Subject: Duke Power Company LLC
Oconee Nuclear Station, Unit 3
Docket Nos. 50-287
Third Ten Year Inservice Inspection Interval
Request for Relief No. 05-ON-002, Rev 1

Request for Additional Information
With Response Re:

05-ON-002

TECHNICAL LETTER REPORT
REQUEST FOR ADDITIONAL INFORMATION
ON THIRD 10-YEAR INSERVICE INSPECTION INTERVAL
REQUEST FOR RELIEF 05-ON-002
FOR
DUKE POWER COMPANY
OCONEE NUCLEAR STATION, UNIT 3
DOCKET NUMBER 50-287

(W5)
3-RPV-WR35
B01.021.003

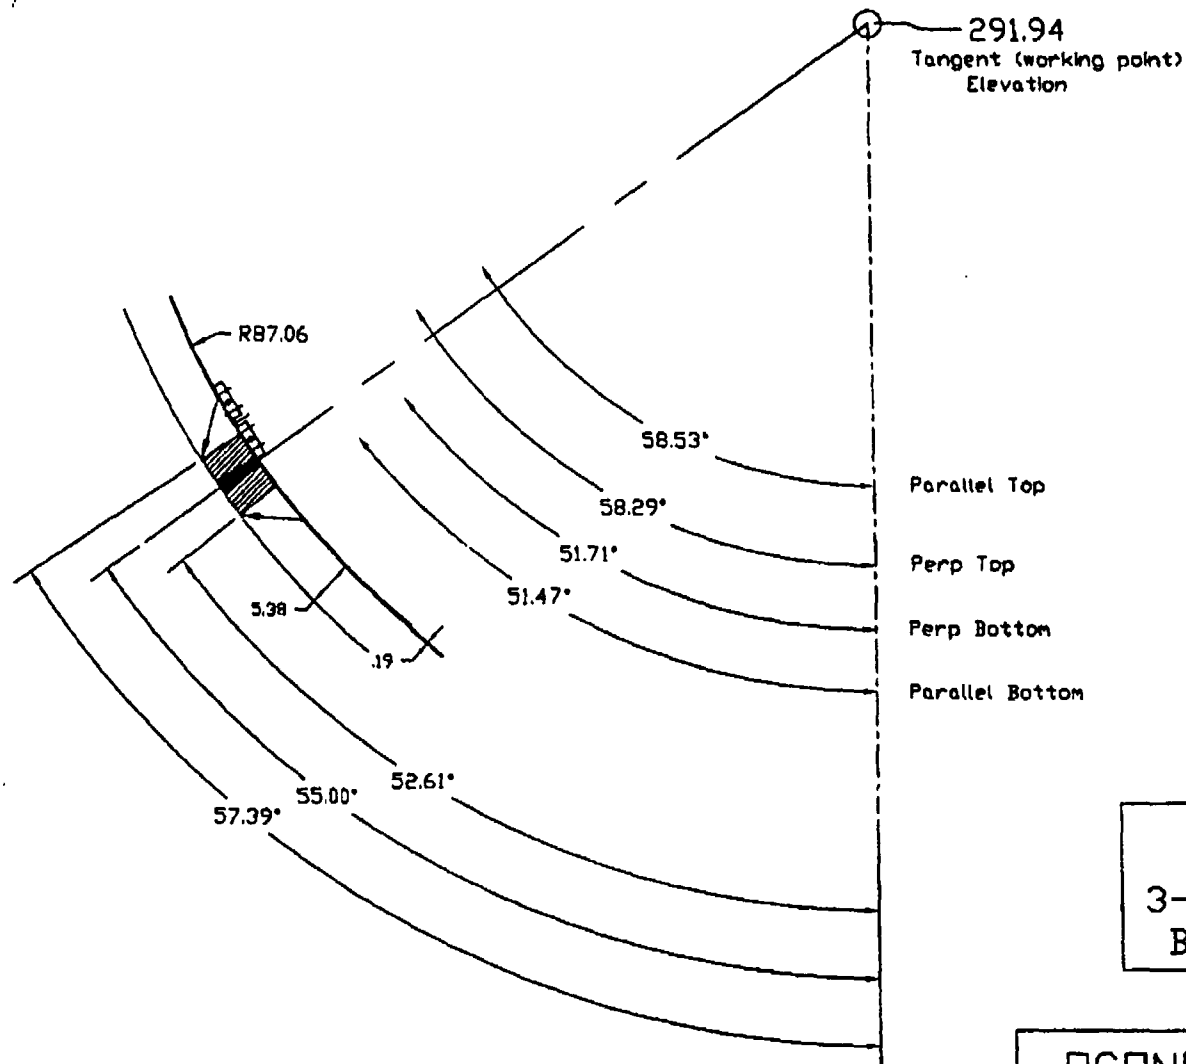
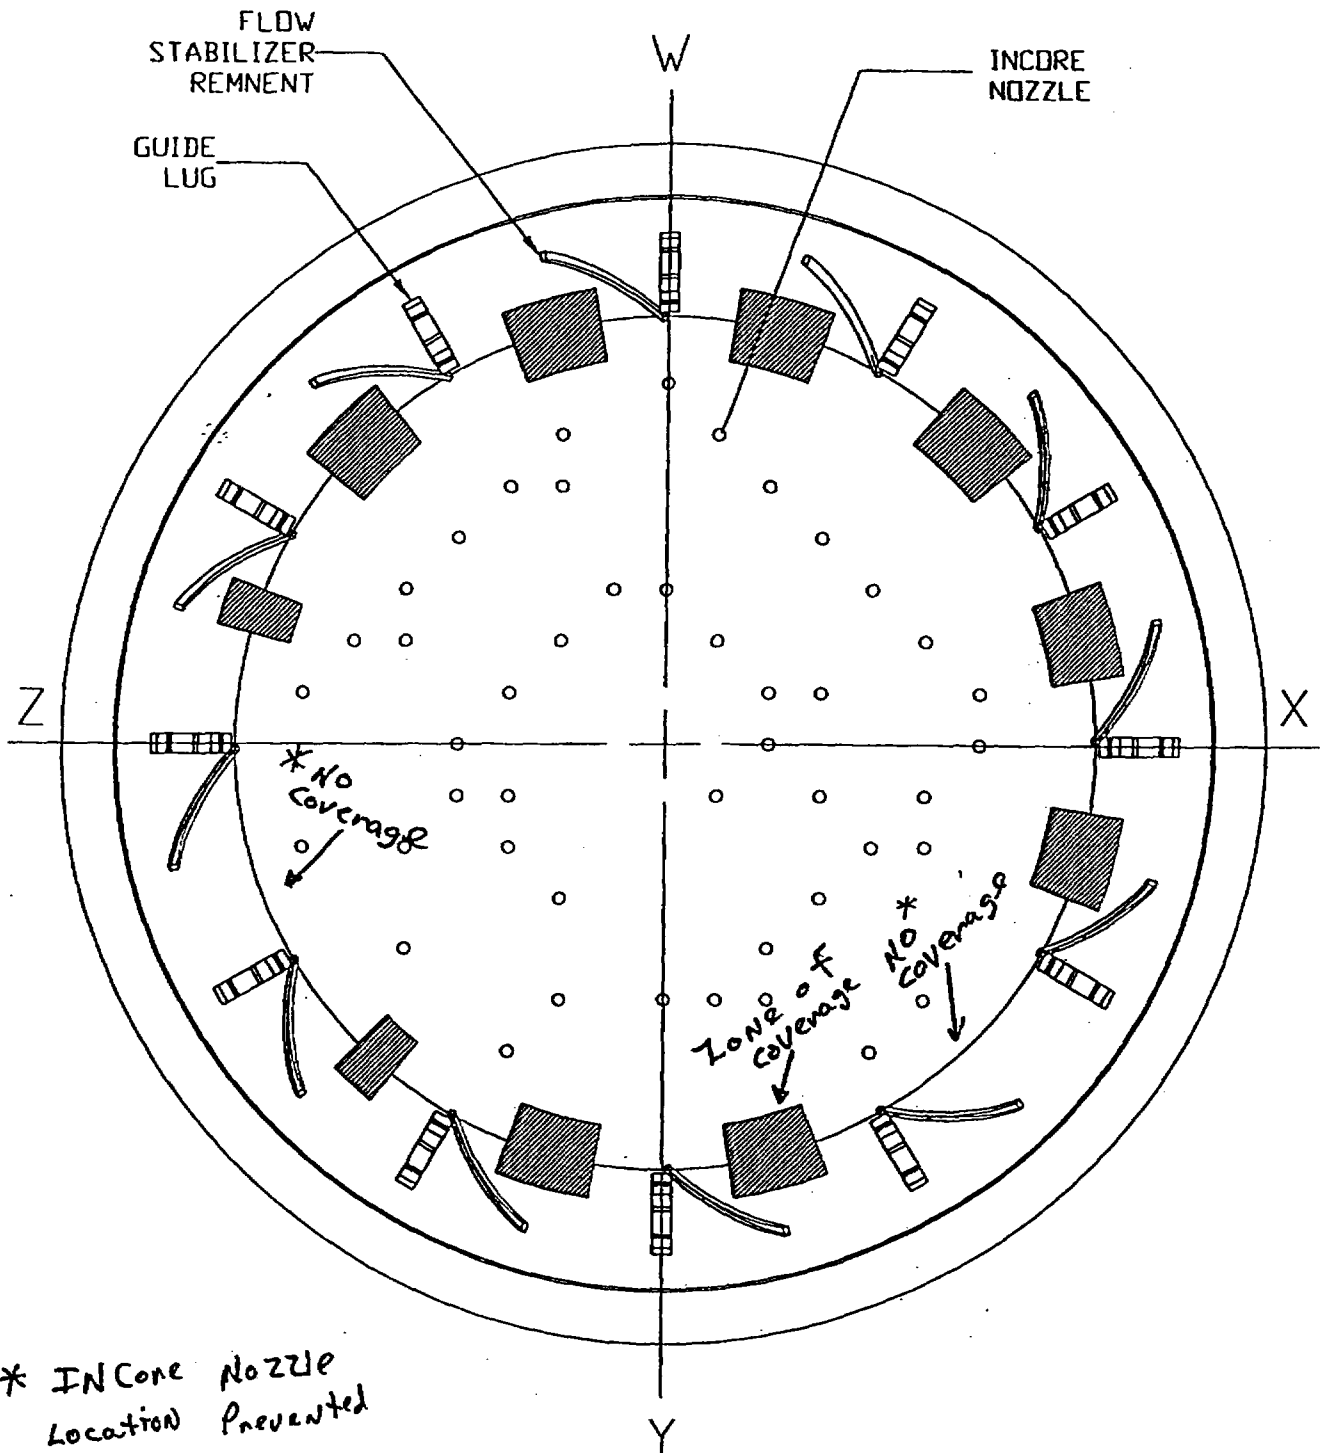
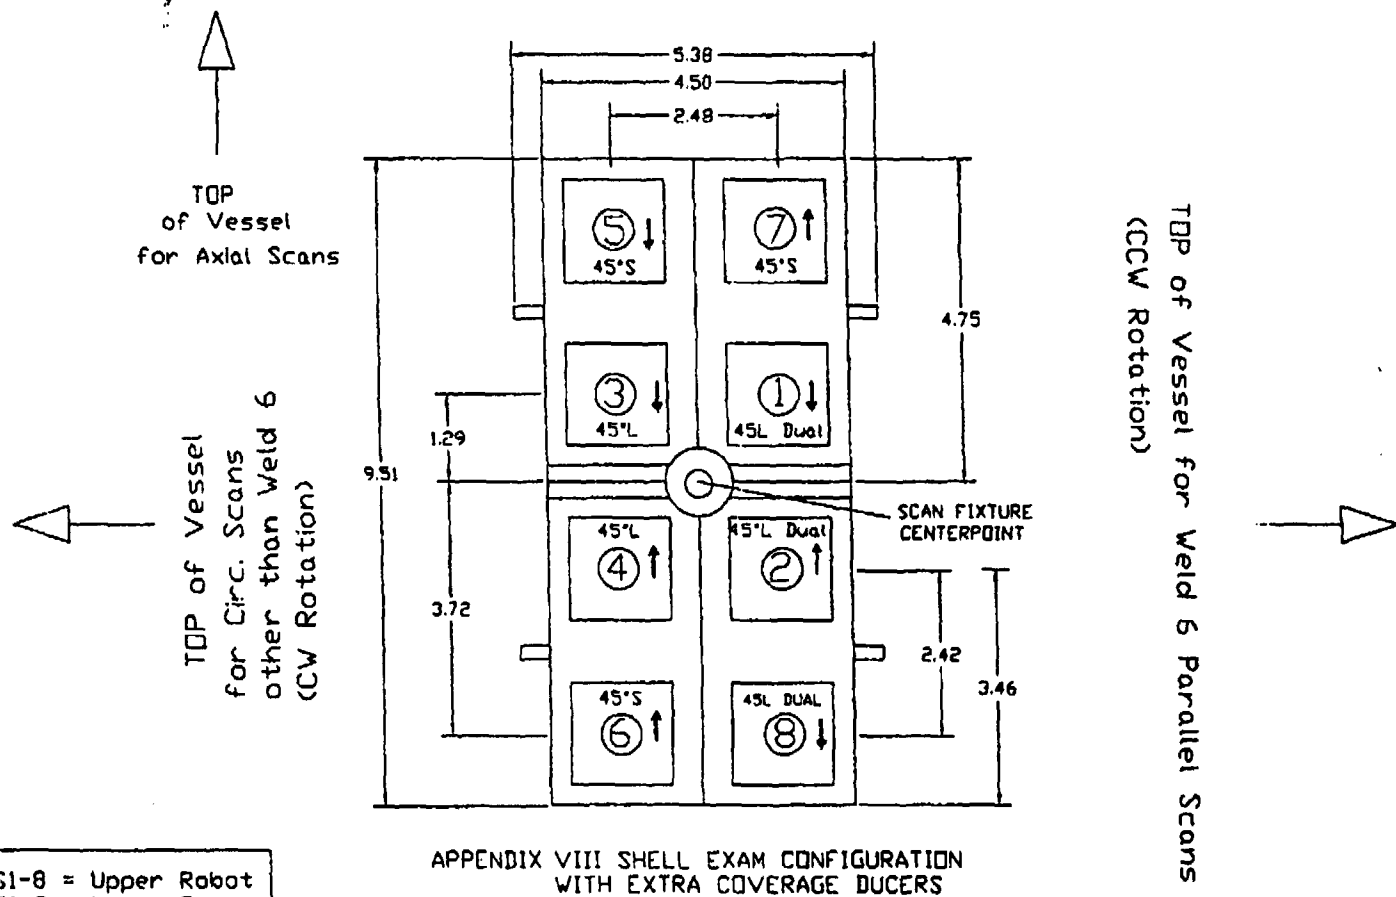
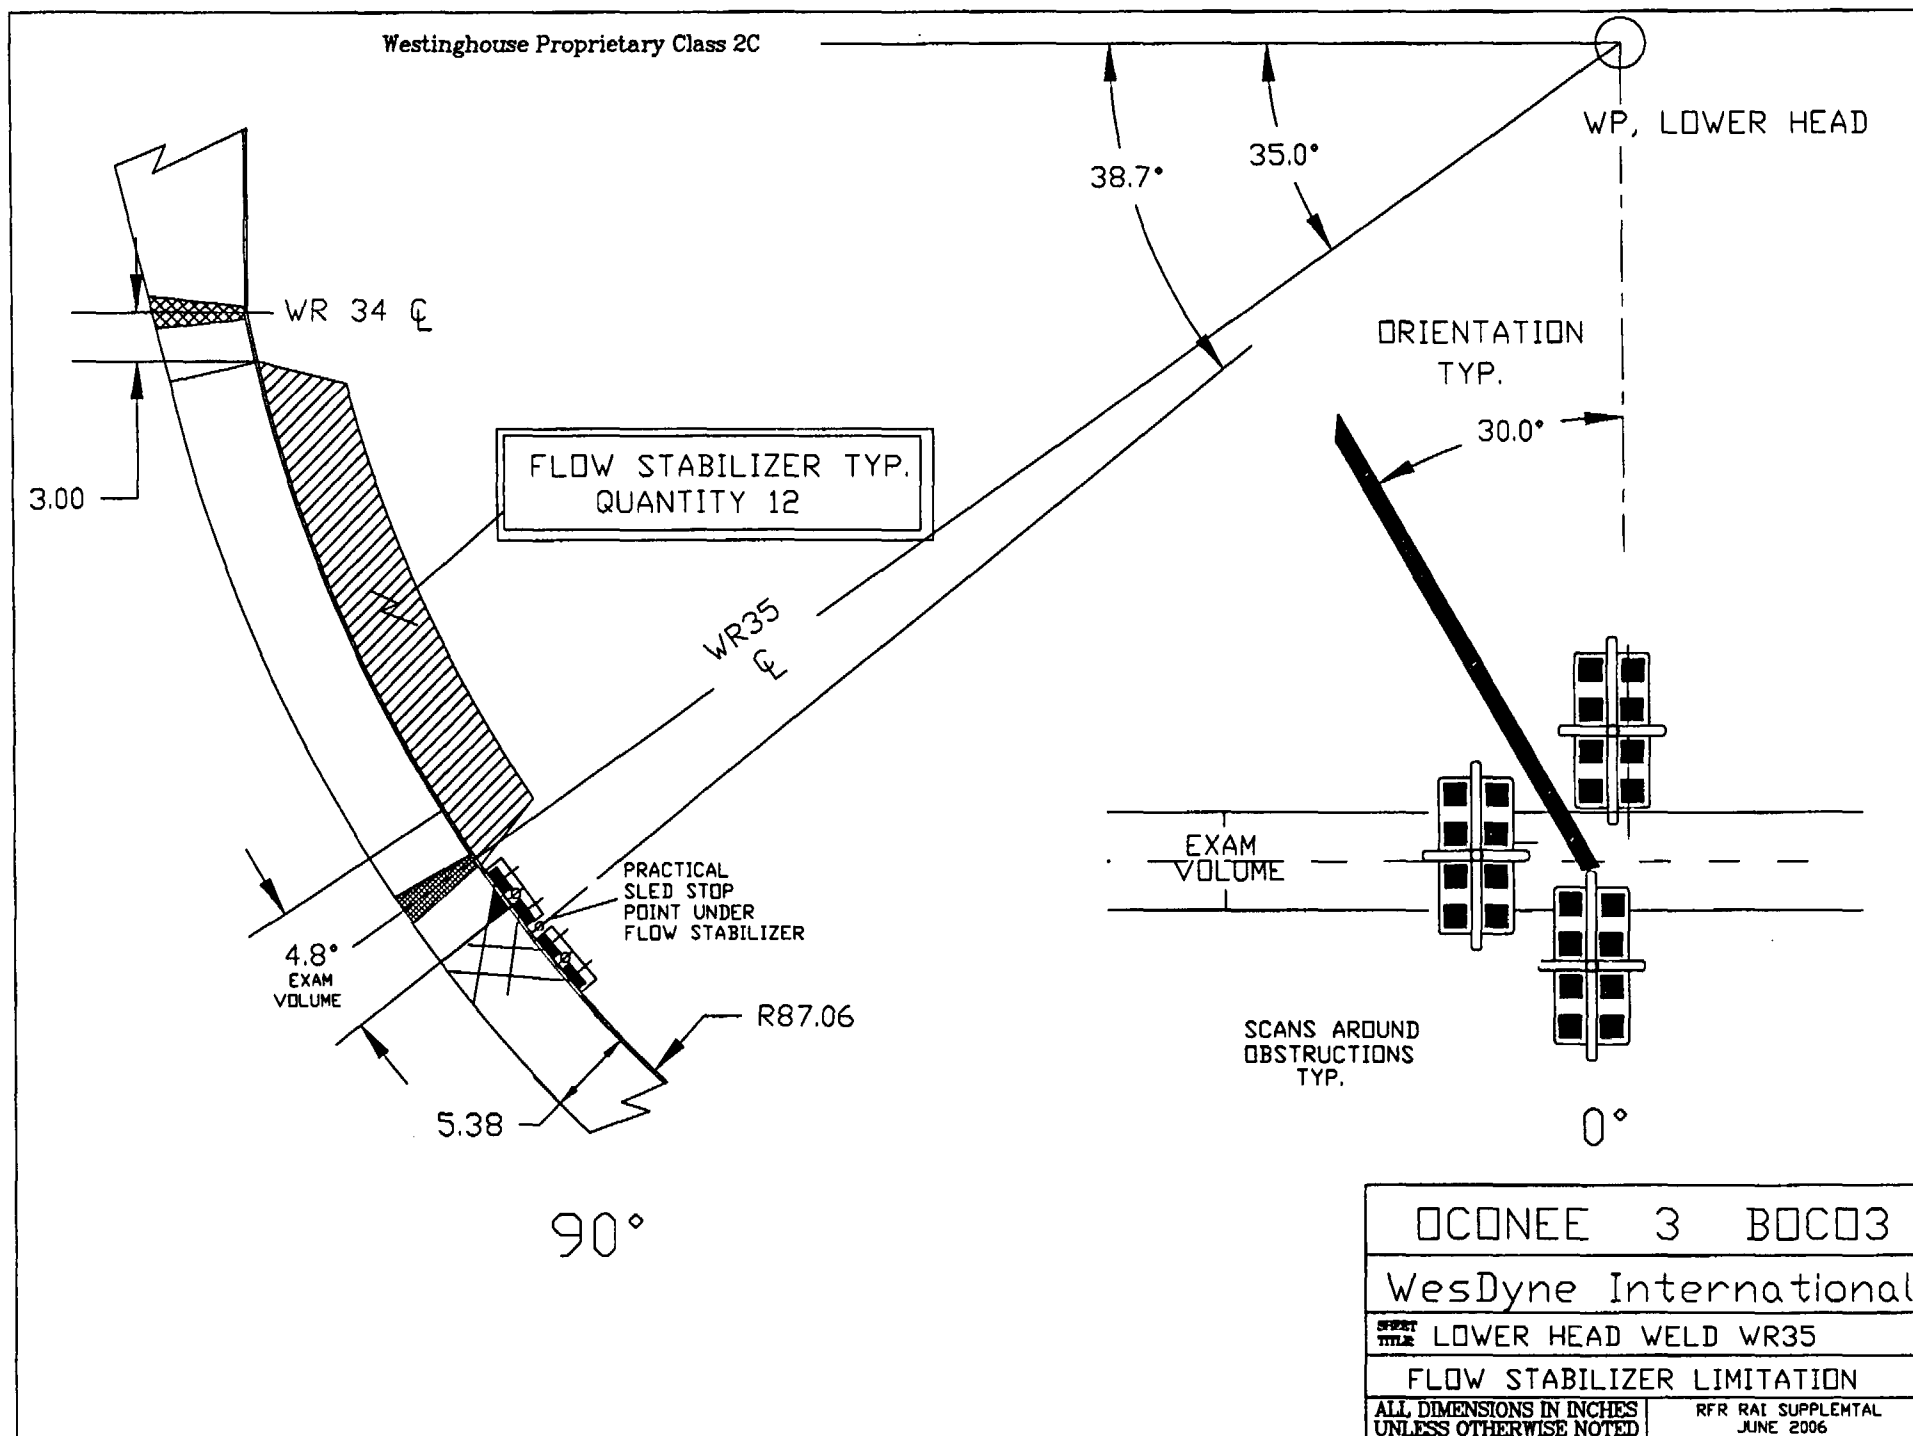
- 2.2(a) For RPV shell-to-lower head Weld 3-RPV-WR34, the licensee stated that core support/guide lugs caused restrictions to the scanning access for these welds. Please be more specific as to how the RPV appurtenances restrict scanning access. Describe the remote UT fixture, including the transducer sled dimensions, and how the guide lugs prevented placing the transducer sled in a proper position for performing the examinations. Provide similar information for lower head ring Weld 3-RPV-WR35.

For weld 3-RPV-WR35:

Pages 2 of 5, 3 of 5, 4 of 5 and 5 of 5 were added to attachment C that should help to answer the question.

(note: Pages 2 of 5 and 3 of 5 should have been sent with the original request for relief but may have been lost during the transmittal process. Pages 4 of 5 and 5 of 5 are new pages.)

During ultrasonic examination, 100% coverage of the required examination volume could not be obtained. The examination coverage was limited to 50%. The percentage of coverage reported represents the aggregate coverage from all scans parallel and perpendicular to the weld. The flow stabilizers, core guide lugs and in-core nozzles that restrict the scanning surface, as shown on the Attachment C drawing, caused the limitations. The weld and adjacent base material were examined using 45° refracted shear waves and 45° refracted longitudinal waves. There were no recordable indications found in the areas that were examined. In order to achieve more coverage the flow stabilizers, core guide lugs and in-core nozzles would have to be moved to allow greater access for scanning, which is impractical.

(W1)
3-RPV-WR19
B01.030.001

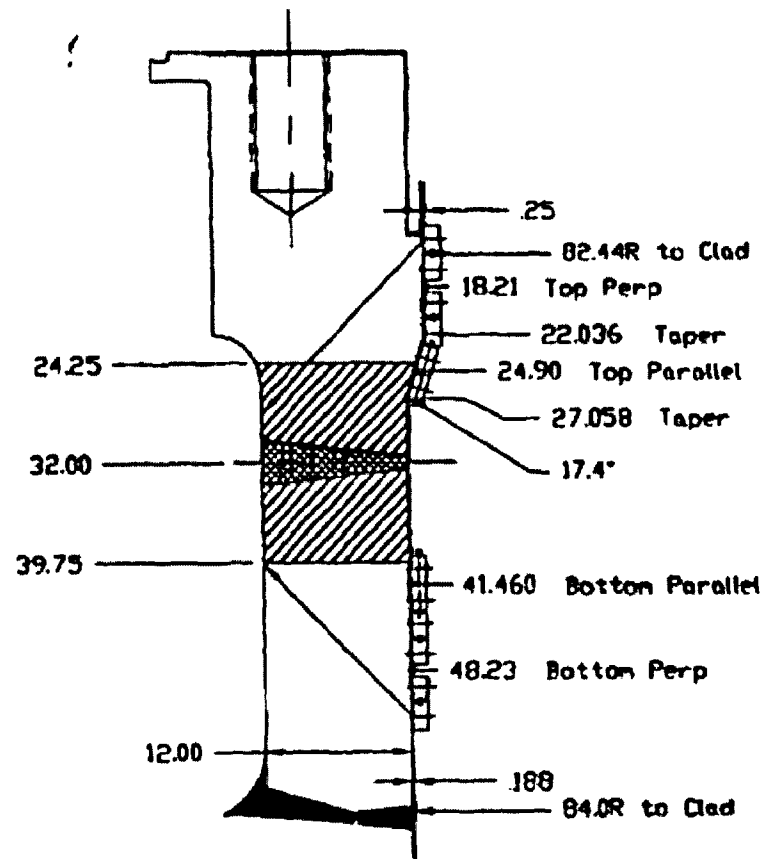
- 2.2(b) The licensee stated that ultrasonic examination of Welds 3-RPV-WR34, -WR35, and -WR19 were conducted using personnel, equipment and procedures qualified in accordance with ASME Section XI, Appendix VIII, Supplements 4 and 6, 1995 Edition with the 1996 Addenda, as administered by the industry's Performance Demonstration Initiative. This is appropriate for Welds 3-RPV-WR34 and -WR35, because they are both RPV shell and head welds, and are required by CFR to be inspected by these type of performance-demonstrated methods.

However, Weld 3-RPV-WR19 is a shell-to-flange weld, and is specifically excluded, by Article I-2000, from the requirements of Appendix VIII. This weld must be examined using the procedures, personnel and equipment requirements listed in ASME Code Section V, Article 4, as supplemented by ASME Code Section XI, Article I.

While the NRC would like to encourage the use of performance-demonstrated UT methods for components not currently within the scope of Appendix VIII, the actual ASME Code requirement for Weld 3-RPV-WR19 at Oconee 3 is to use Article 4 of ASME Section V, supplemented by Article I of ASME Section XI. The licensee has not met this requirement, and therefore, must propose an alternative, in accordance with 10 CFR 50.55a(a)(3)(I), to use personnel, equipment and procedures qualified in accordance with ASME Section XI, Appendix VIII, Supplements 4 and 6, 1995 Edition with the 1996 Addenda, for Weld 3-RPV-WR19.

Duke submitted Relief 04-GO-002 on 7-14-2004, which was approved by the NRC by letter of 10-20-2004. This was a proposed alternative to use personnel, equipment and procedures qualified in accordance with ASME Section XI, Appendix VIII, Supplements 4 and 6, 1995 Edition with the 1996 Addenda, for several welds, including Weld 3-RPV-WR19.

Core Flood Nozzle to Shell TAN, Star IR Exams

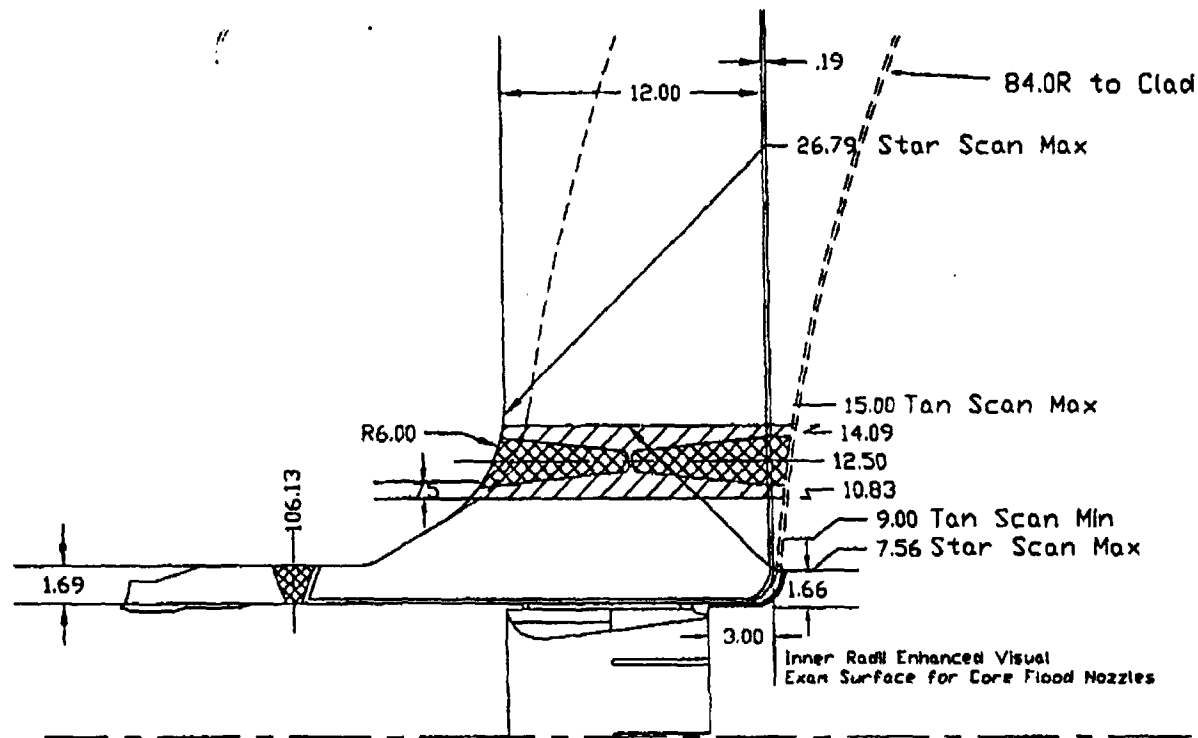
- 2.3(a) These nozzle-to-vessel welds are on core flood nozzles located at 0 and 180 degrees on the RPV. The licensee stated that these examinations were performed during December 2004, and that examination of nozzle-to-vessel Welds 3-RPV-WR54 and -WR45A were conducted using personnel, procedures and equipment qualified in accordance with ASME Section XI, Appendix I, 1989 Edition, with no Addenda.

However, 10 CFR 50.55a(g)(6)(ii)(C) requires licensees to implement the 1995 Edition, with 1996 Addenda, of ASME Section XI, Appendix VIII, Supplements 5 and 7, for RPV nozzle-to-vessel welds examined after November 22, 2002. These Supplements list the requirements for performance demonstration of procedures, personnel and equipment. The licensee should clarify whether the stated UT qualifications

were mistakenly identified or explain why the examination of Welds 3-RPV-WR54 and -WR54A were not performed using personnel, procedures and equipment qualified under Supplements 5 and 7, as required by CFR.

The wrong reference was used. Paragraph H of the Original Relief Request will be revised to read as shown below:

Ultrasonic examination of areas/welds for item numbers B03.090 were conducted using personnel, equipment and procedures qualified in accordance with ASME Section XI, Appendix VIII, Supplements 4, 6, & 7, 1995 Edition with the 1996 Addenda. Although limited scanning prevented 100% coverage of the examination volume, the amount of coverage obtained for these examinations provides an acceptable level of quality and integrity.
(See Paragraph I for additional justification.)

Note: Supplement 5 was not used to examine the nozzle inside radius because an enhanced visual examination was performed in lieu of UT examination per Code Case N-648-1.
